STATE OF DELAWARE
EXECUTIVE DEPARTMENT
OFFICE OF MANAGEMENT AND BUDGET
Budget Development, Planning and Administration
State Planning Coordination

RE: PLUS 2008-09-05; The Evans Farm

According to the information received, you are seeking site plan approval through Sussex County for 200 residential condominiums.

Figure 1: NRCS soil survey update mapping in the immediate vicinity of the Evans Farm

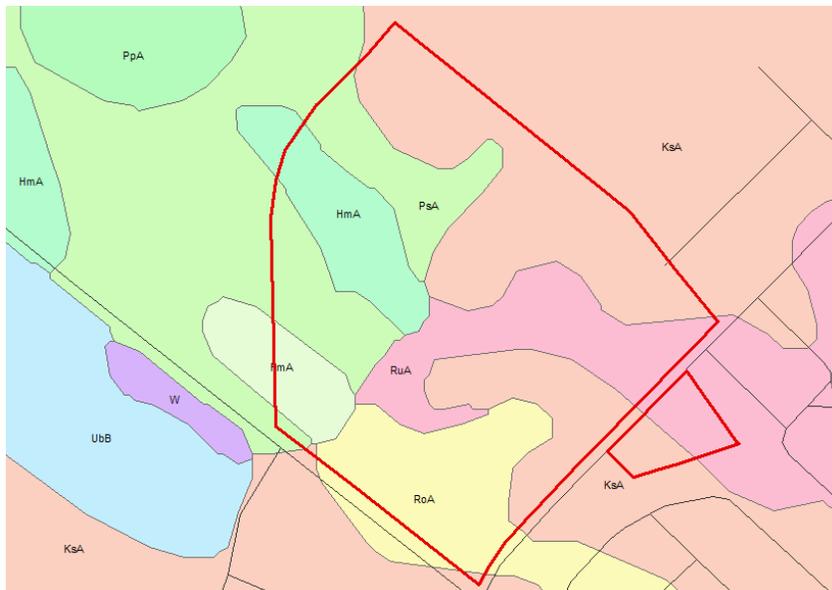
Based on the NRCS soil survey update, Rosedale (RoA), Rumford (RuA), Fort Mott (FmA), Hambrook (HmA), Pepperbox-Rosedale complex (PsA), and Klej (KsA) were mapped in the immediate vicinity of the proposed construction (See figure 1). Rosedale, Rumford, Fort Mott and Hambrook are well-drained upland soils that, generally, have few limitations for development. Pepperbox-Rosedale complex is a moderately well to well-drained upland soil that has moderate to few limitations for development. Klej is a somewhat poorly-drained transitional soil that is likely to have both wetland and upland soil components.

Figure 2: SWMP mapping in the immediate vicinity of the Evan Farm

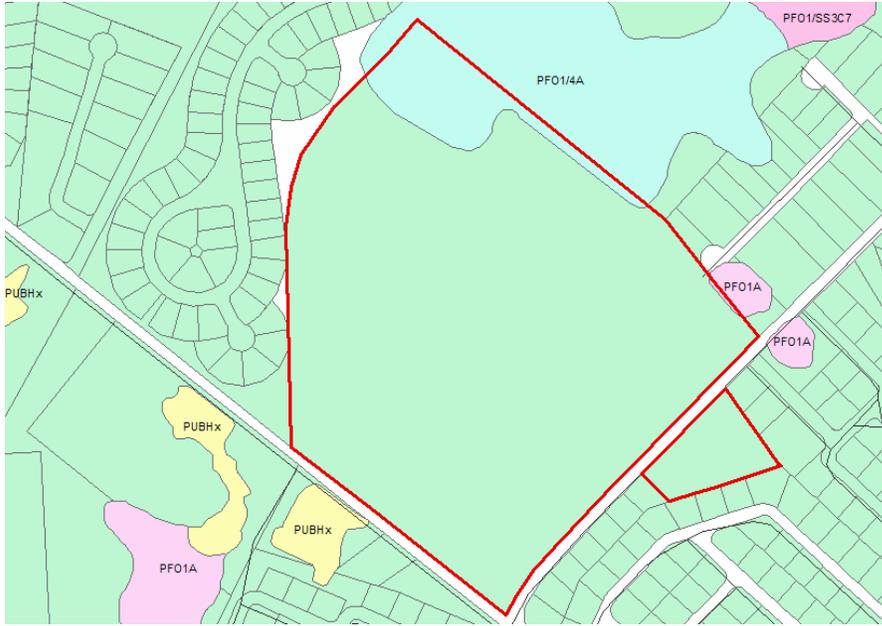
Based on the Statewide Wetland Mapping Project (SWMP) maps, palustrine forested wetlands (PF01/4A) were mapped in the far northern portion of the area proposed for construction (See figure 2).

Although there are no blue line features on the property, there are two drainages visible on the aerial photography that should be checked to see if they fall under the jurisdiction of the Subaqueous Lands Act. These two drainages flow to Collins Creek. The Wetlands and Subaqueous Lands office should be contacted to determine if the drainages are jurisdictional. Additionally, the SWMP map shows wetlands regulated by the Corps of Engineers on the north-northwest part of the property. The developer should contact the Corps of Engineers to get a jurisdictional determination for the property.
